SERVICE BULLETIN

APPLICABILITY: 2019-22MY Ascent

NUMBER: 07-219-23

SUBJECT: Genuine Alternative Battery Replacement

Remaining Height Is Less Than 2mm

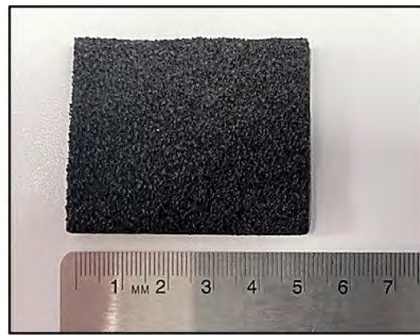
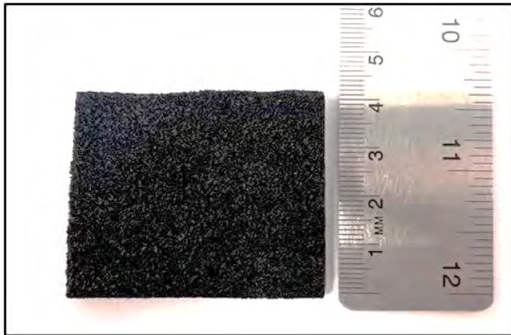
- A. CAREFULLY** cut off and trim the two protrusions on the bottom of the battery tray. This will allow a more streamlined fit when installed on the vehicle. Try to make the cut as flush as possible.

CAUTION: Be sure the protrusions are trimmed flush. The remaining protrusion height **MUST** be less than 2mm to provide proper fitment.

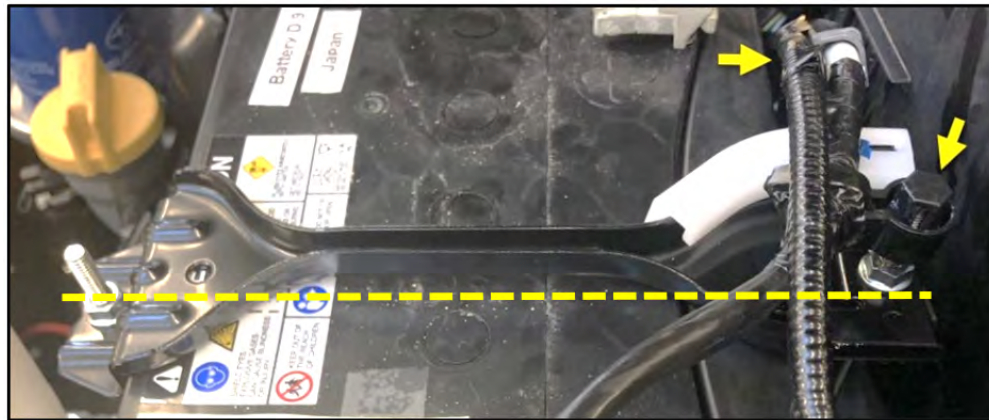
STEP 5: Assemble the **ORIGINAL** battery holder, **NEW** rear holding rod (p.n. 82161SJ000), and the **ORIGINAL** front holding rod as shown below. The original rod nut can be transferred to the new rear holding rod.

NOTE: DO NOT discard the original rear rod. This part is to be returned to be returned to the customer.
